REMARKS

Applicant : Patrizio Vinciarelli et al.
Serial No. : 09/611,290
Filed : July 6, 2000
Page : 8 of 8

Attorney's Docket No.: 00614-092002

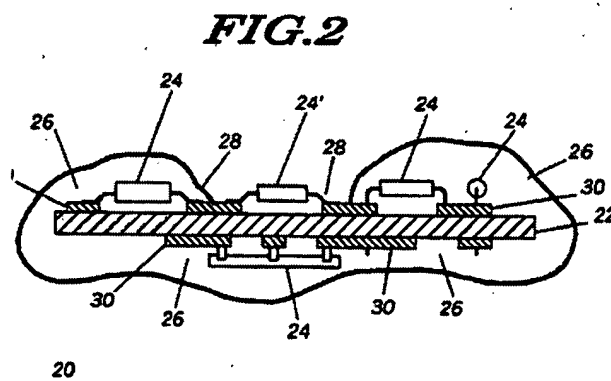
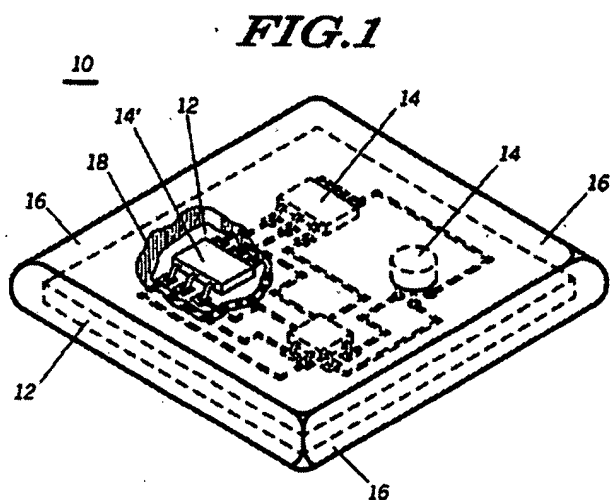
5. Claims 30-33 and 35-39 are rejected under 35 U.S.C. 102(b) as being anticipated by Juskey et al. (U.S. Patent 5,232,758).

Regarding claims 30 and 39, Juskey et al. discloses an apparatus (electronic device 10, 20) as shown in figures 1-2 comprising:

- an electronic device (22), see column 4, lines 52-53, having an outer surface (the surface in which components 24 formed on) and a conductive termination (conductive traces 30), see column 4, line 55 (leads or pins of the components 24), on the outer surface;
- a protective, conformal coating (26), see column 4, line 56), on the surface of the electronic device (22); and
- a window (28), see column 4, line 64) formed in the protective coating (26) to expose a portion of conductive the termination (30 or the pins of the components 14),
- wherein the exposed portion of the conductive termination (a portion in which is not covered by the coating) is recessed in the window of the conformal coating (see top view of figure 1 and side view of figures 2).

Amended claim 30 requires, among other things, that the protective coating formed on the surface of an electronic device have a first window that exposes at least a portion of a first conductive termination without exposing any other conductive terminations on the device.

Juskey does not disclose or suggest such a device. As illustrated in its FIGS. 1 and 2, Juskey describes an electronic device 12/22 that is encapsulated in a conformal coating 16/28 having an single opening 18/28 that exposes multiple conductive terminations:

As clearly shown in these figures, the opening in Juskey does not expose a first conductive termination without exposing other conductive terminations of device 12/22 as required by claim 30. Moreover, claim 30 also requires that the window define a boundary for a solder connection between a terminal and an external circuit, which is also not disclosed or suggested in Juskey. Accordingly, Applicants submit that claim 30 is patentable for at these reasons. Claims 31-37 and 39-40 depend from claim 30, and, therefore, are patentable for at least the same reasons.
